PUBLIC INTEREST REVIEW FOR GROUNDWATER APPLICATIONS

TO:		Wate	r Rights Se	ection				Date	01/	12/2018		
FROM:		Grou	ndwater Se	ection	Ø	Phillip	I. Marcy					
SUBJE	CT:	Appli	cation G-	18411			wer's Name ersedes rev	view of <u>05/</u>	02/2017	Date of Re	view(s)	
OAR 69 welfare, to determ	0-310-13 safety ar nine whe	30 (1) 7 ad heal ther th	The Departn th as descri e presumpti	<i>bed in ORS</i> . on is establis	resume that 537.525. Do shed. OAR	a propose epartment 690-310-1	d groundwa staff review 40 allows t	ater use will en groundwater the proposed un agency policy	application se be modi	ns under OA fied or cond	R 690-31 itioned to	0-140 meet

Application G-18411 Date: 01/12/2018 Page

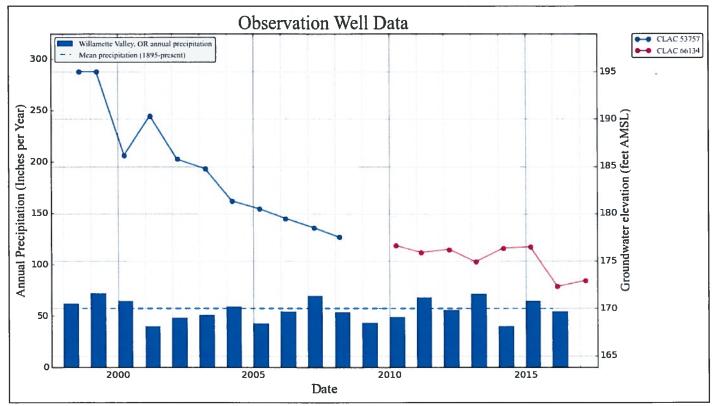
The proposed POA well is currently measured annually under Condition 7C, requiring measurements for a period of 7 years, under permit G-16545. In the attached hydrograph for this well, water levels exhibited a decline between 03/2015 and 03/2016 of greater than 3 feet. While this is not a significant decline and may not illustrate a long-term trend in the local aquifer, the water level trend in the proposed POA well correspond with that of nearby CLAC 53757, whose record spans the period of 1998-2008. Taken together, these records show a decline of ~23 feet over the course of 18 years in this local system. However, an investigation of broader trends within the aquifer (both spatially and temporally) suggests that taken as a whole, declines cited in the initial evaluation are not systemic in the Troutdale Aquifer. Furthermore, it appears that long-term declines in the local Troutdale aquifer system have begun to slow in recent years (see attached hydrograph from 1998-present), the cause of which is unknown at this time. Due to a high level of concern regarding sustainability of the groundwater source, the ongoing viability of senior water rights, and the potential for surface water interference, condition 7N is recommended which requires yearly measurements for the duration of the water right to ensure long-term documentation of groundwater level declines.

Water-Level Trends in Nearby Wells

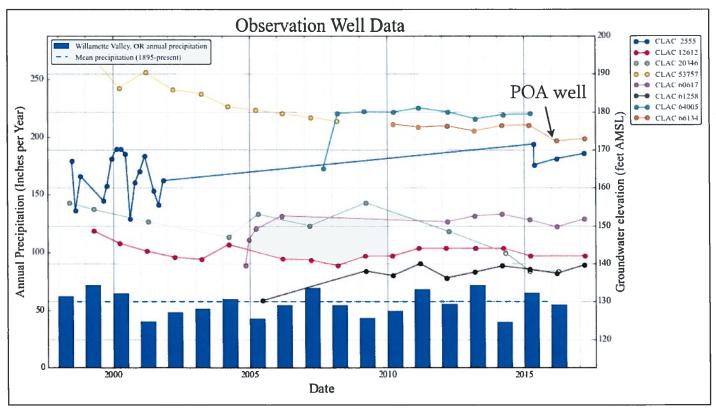
Groundwater elevations in the proposed POA well display fluctuations totaling less than 10 feet since 2010, but a longer term declines evidenced by data from nearby wells producing from the same aquifer system is cause for concern.

Data from wells within the Troutdale aquifer within the Pudding River WAB above Mill Creek (#151) do not reflect wholesale regional declines. A map showing locations of these observation wells is included below.
